MEMO: SUPPLEMENTARY NOISE ASSESSMENT

TO: Simon Hedley, Lands and Survey
PROJECT REF: 640001

SOL QUARRIES LTD NOISE ASSESSMENT ADDENDUM

Figure 1: Boundary setback of crushing plant (350-metres from north-eastern and south eastern adjoining properties)

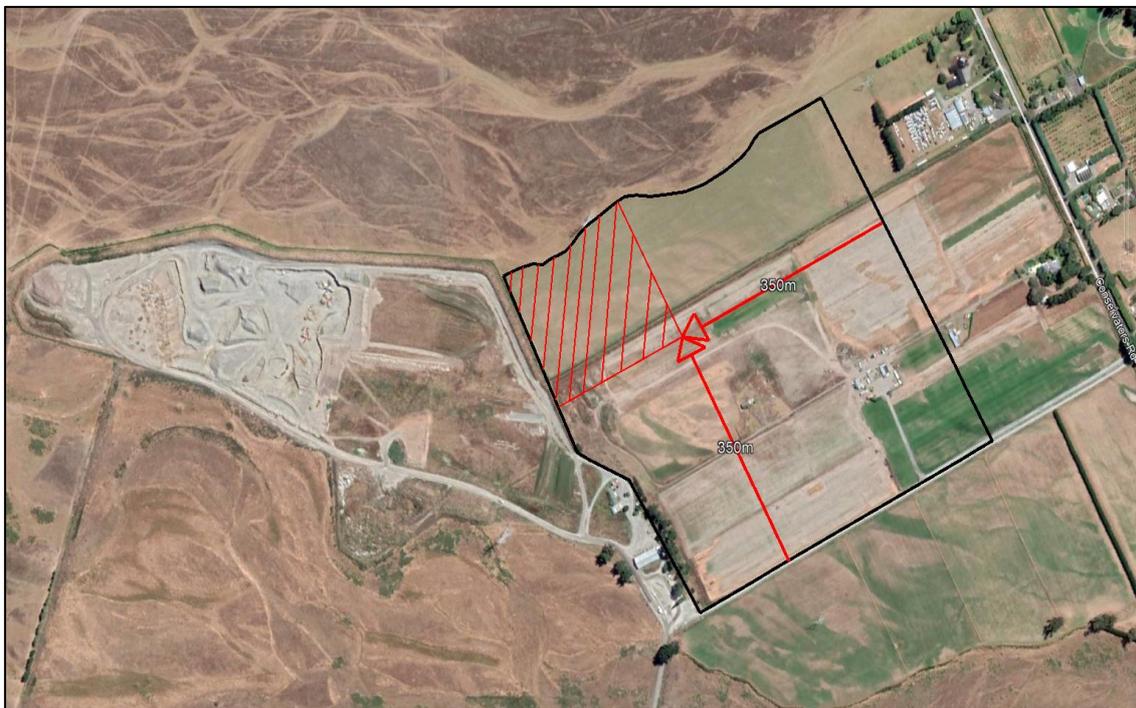
- *The AEE states that there will be two mobile crushing units on site. Please provide details of the closest position the crusher will be located to the site boundaries. In addition, the noise report has not clearly indicated where the crusher is proposed to be located when the predicted noise levels were calculated. Please include these details within the Noise Report.*

2. Since the initial assessment, SOL Quarries Ltd has decided, for operational reasons, to implement a 350-metre setback from the north-eastern and south-eastern site boundary related to crushing of gravel, stockpiling of processed aggregate or pit-run and loading trucks. SOL Quarries Ltd has advised that these activities will not take place within the area defined in Figure 1, below. The aforementioned activities will be limited to an area setback 350-metres from the north-eastern and south-eastern site boundaries. The only proposed activities to take place within 350-metres of this north-eastern and south eastern setback are:

- Stripping soil;
 - Excavation of gravels;
 - Clean fill; and
 - Site rehabilitation.
3. The initial operational phase noise model (13 February 2019) did not considered the 350-metre setback, as the setback had not been defined at the time. Rather, the initial model calculated the entire final footprint of the proposed Quarry extension as a basis for

modelling the noise effects of all the quarry activities. The Operational Noise Dispersion model has been updated (refer to Attachment 1) to provide for the setback changes.
